SAFETY EVALUATION REPORT ON THE 1981 VERSION OF THE WESTINGHOUSE  
LARGE BREAK ECCS EVALUATION MODEL

1.0 INTRODUCTION

FIGURE 1

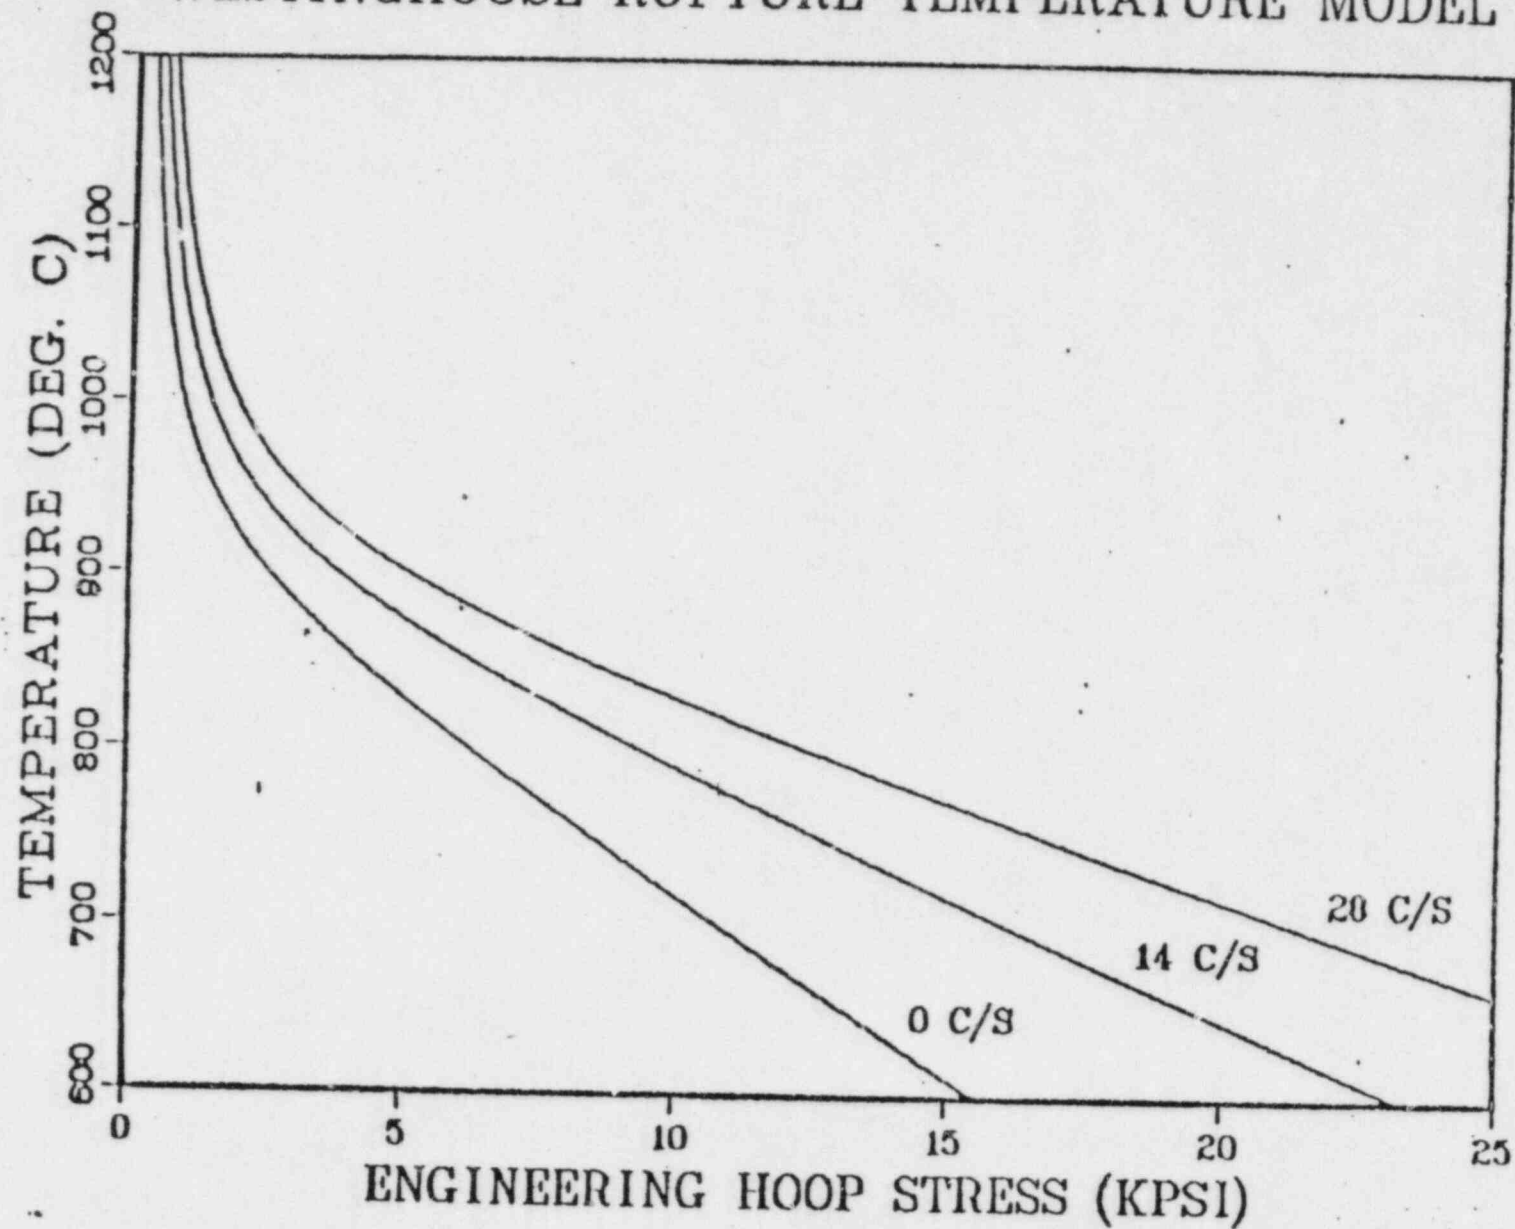
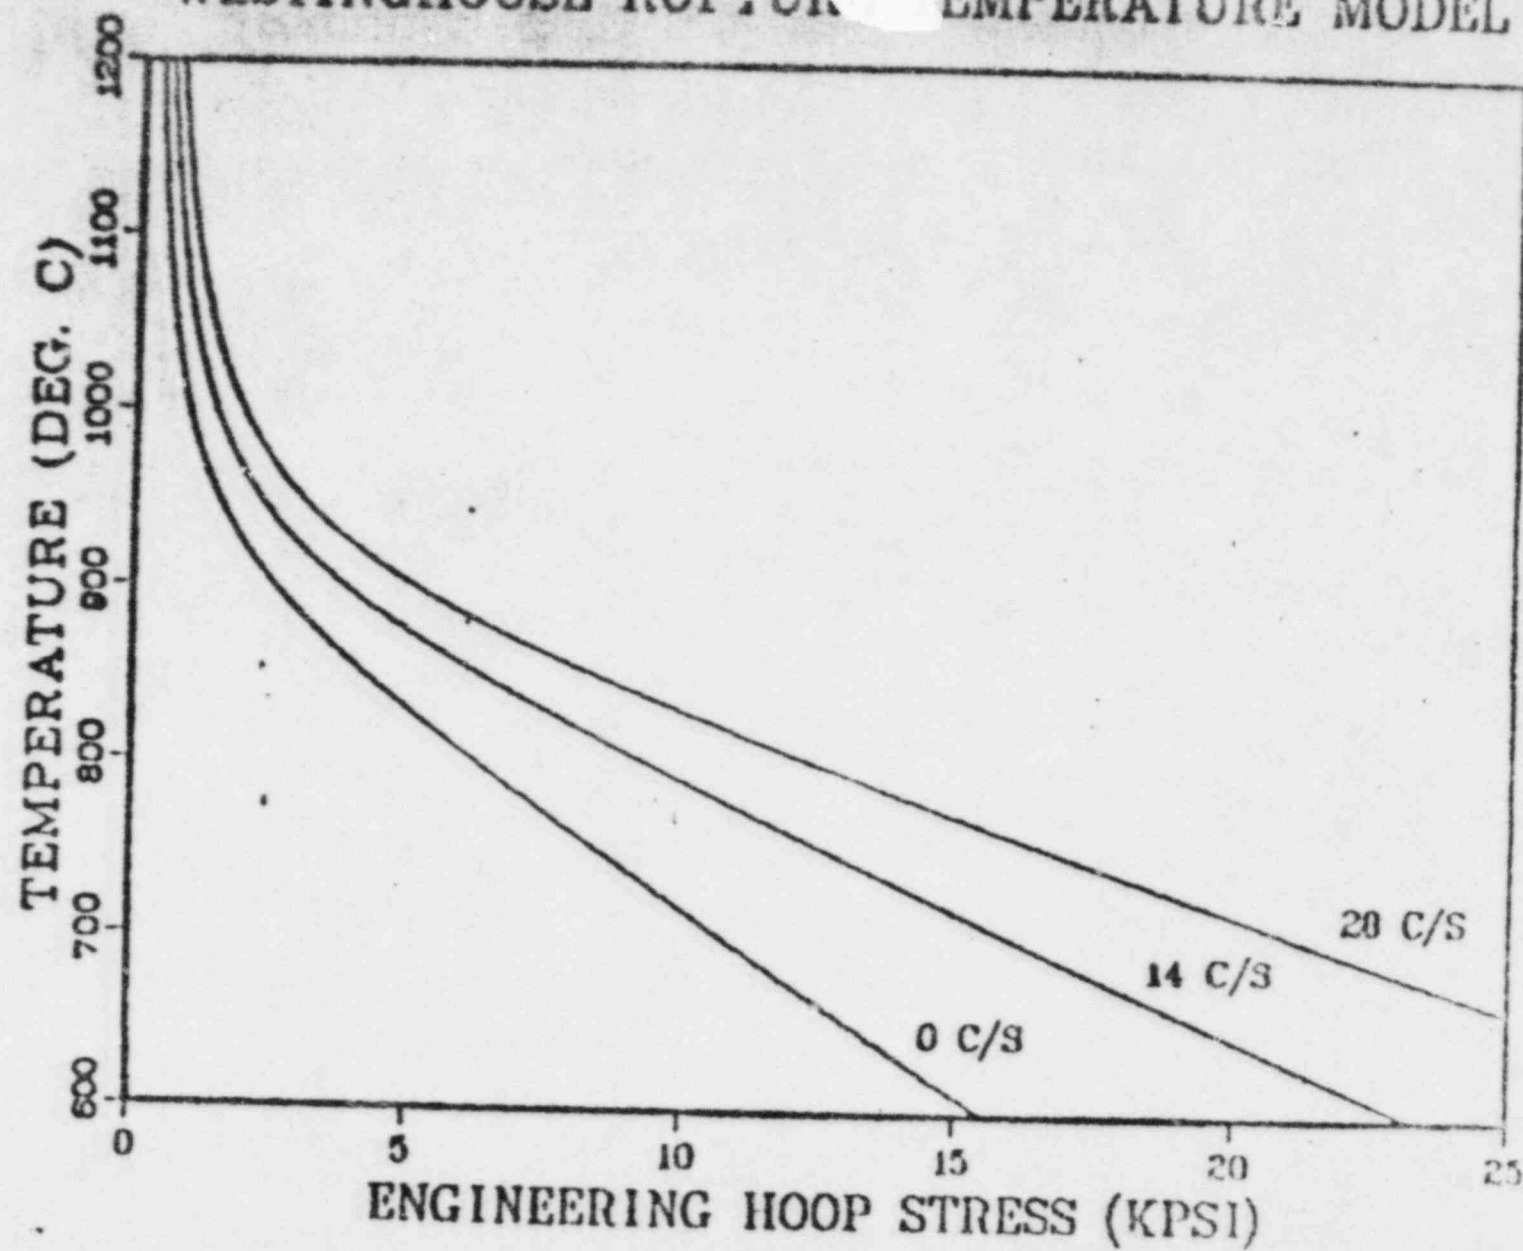
The cladding rupture temperature model is depicted in Figure 1. Westinghouse has programmed the rupture temperature model in tabular form for 0, 14, and  $28^{\circ}\text{C/s}$  ramp rates. Westinghouse conservatively uses the  $28^{\circ}\text{C/s}$  ramp rate correlation for rates  $\geq 28^{\circ}\text{C/s}$ , and the  $0^{\circ}\text{C/s}$  ramp rate correlation for rates  $\leq 0^{\circ}\text{C/s}$ . For intermediate rates, parabolic interpolation at the appropriate ramp rate and cladding wall hoop stress is used to calculate the rupture temperature for each axial node.

Based on the data and analyses contained in NUREG-0630, subsequent data, and our current understanding of plant loss-of-coolant transients, we have concluded that the proposed (1) algorithm for computing heatup rates will provide conservative results for all hypothetical conditions that may be encountered, (2) rupture, strain, and blockage models will predict swelling and rupture without underestimating the degree of swelling or the incidence of rupture, and (3) prerupture strain model will yield strains that are consistent with those observed in prototypical experiments, and the artificial limit on the degree of swelling will yield conservative results. We, therefore, find the models and their proposed applications to be acceptable for all PWRs with fuel supplied by Westinghouse.

FIGURE 2

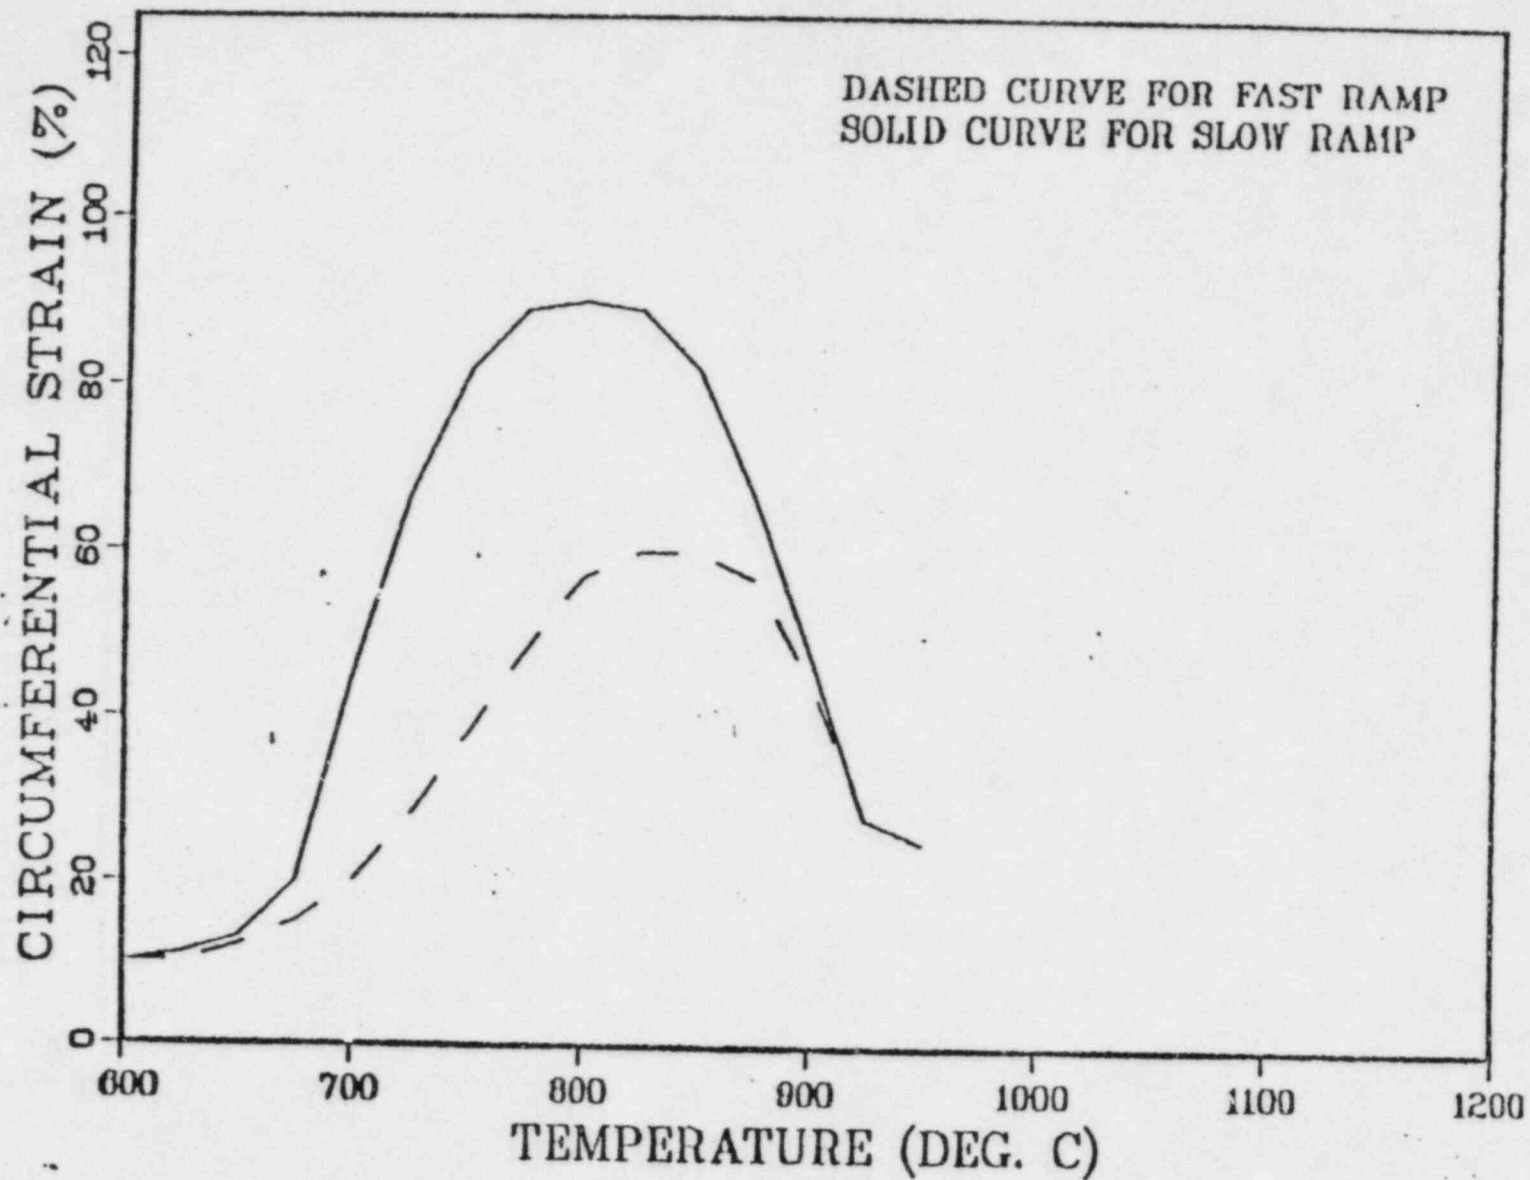
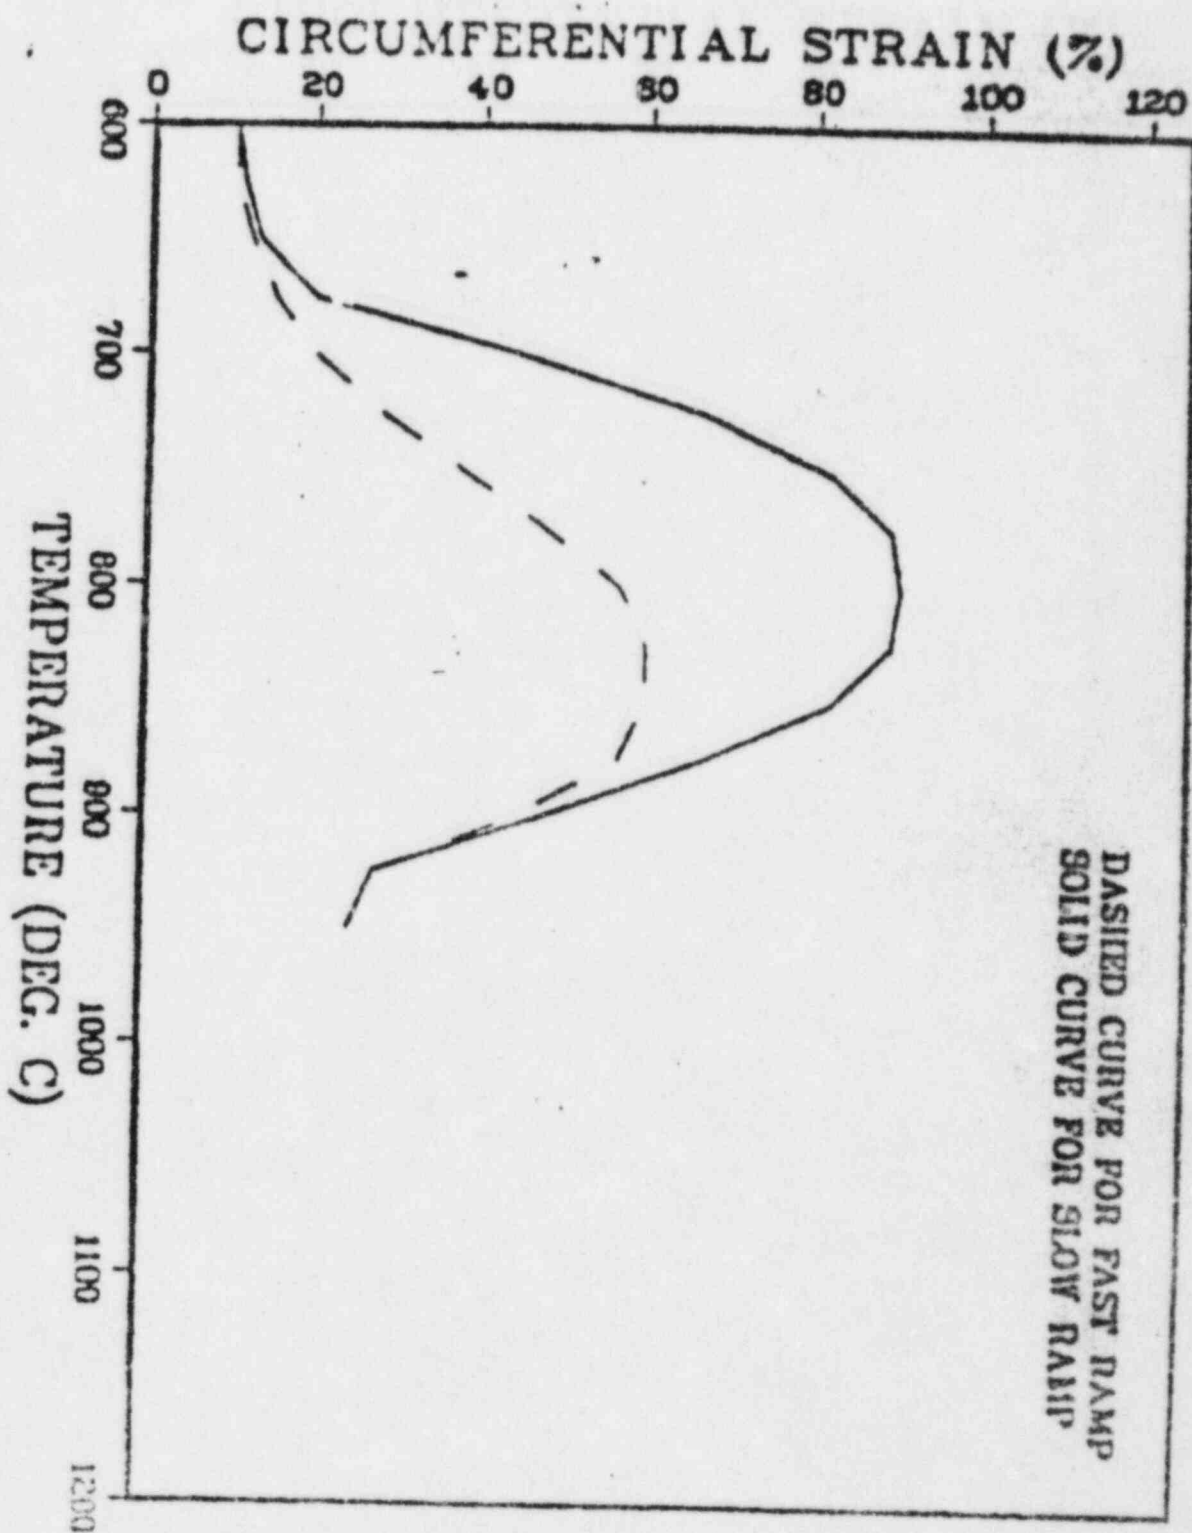
The cladding burst strain model is depicted in Figure 2. For temperature ramp rates  $\leq 10^{\circ}\text{C/s}$ , the slow-ramp correlation (shown as solid curve) is used.

For temperature ramp rates  $\geq 25^{\circ}\text{C/s}$ , the fast-ramp correlation (shown as dashed curve) is used. Strains associated with intermediate ramp rates are determined by linear interpolation.

FIGURE 3

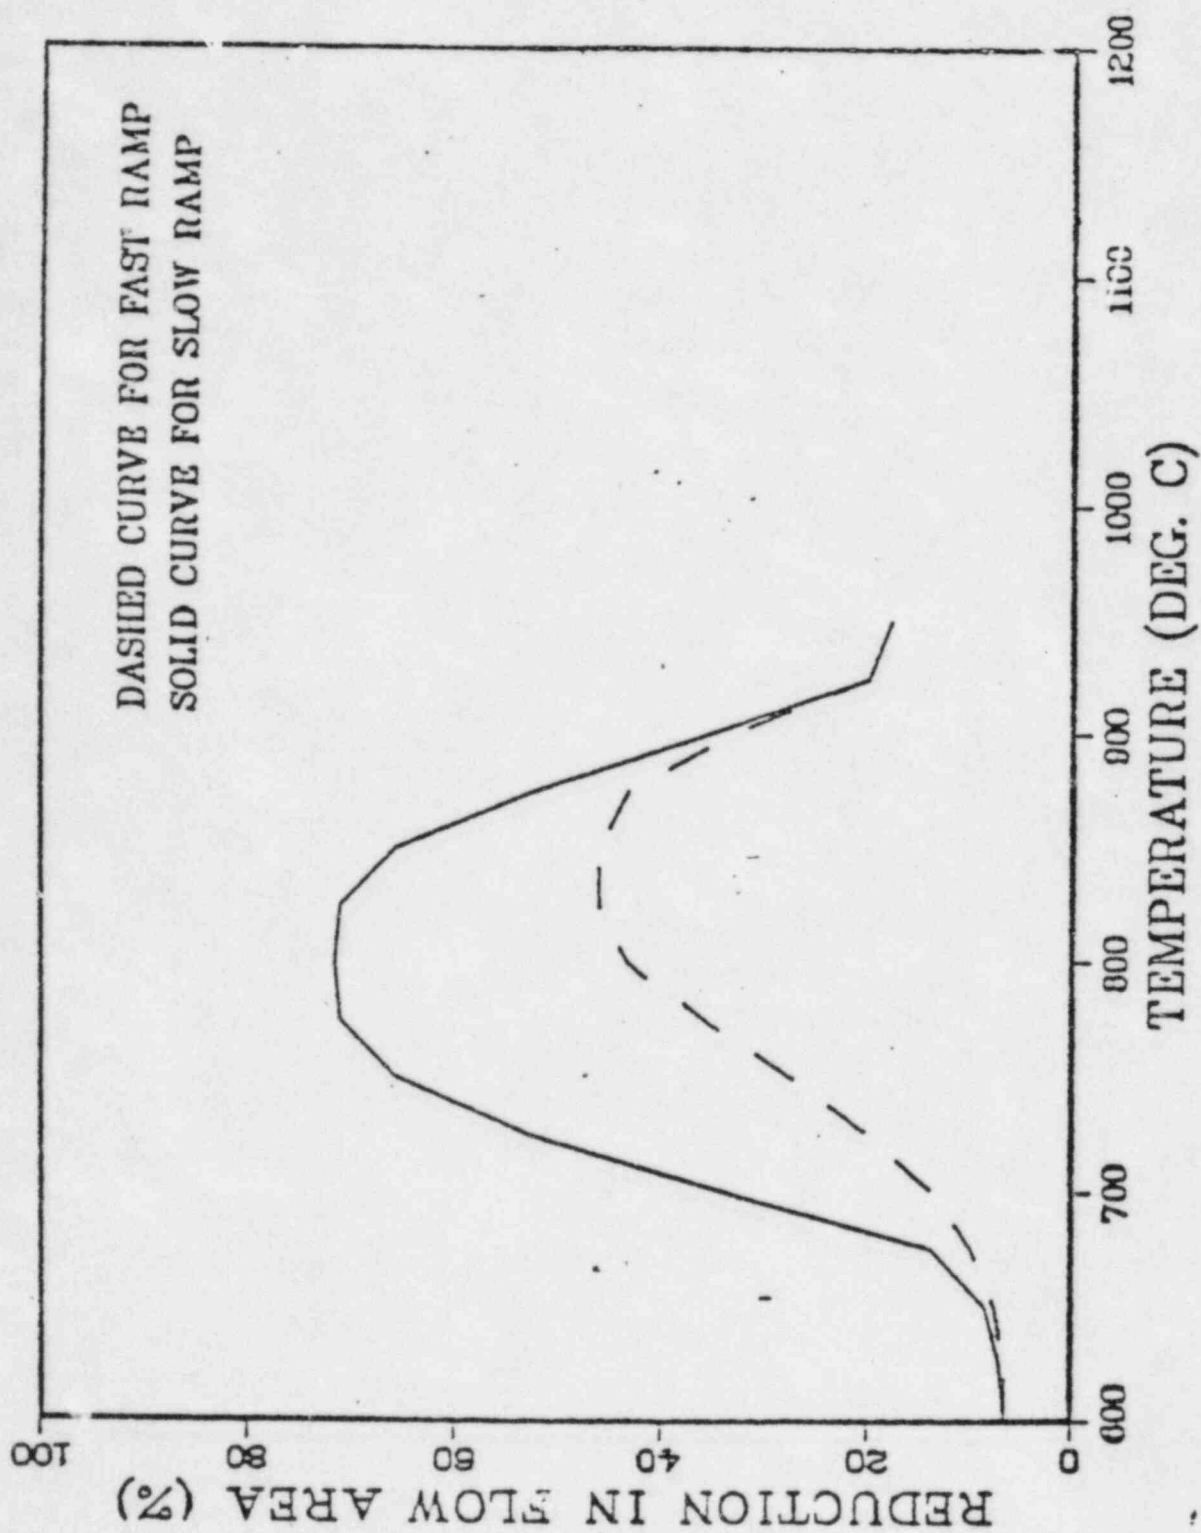
The fuel assembly flow blockage model is depicted in Figure 3. For temperature ramp rates  $\leq 10^{\circ}\text{C/s}$ , the slow-ramp correlation (shown as solid curve) is used. For temperature ramp rates  $\geq 25^{\circ}\text{C/s}$ , the fast-ramp correlation (shown as dashed curve) is used. Blockages associated with intermediate ramp rates are determined by linear interpolation.
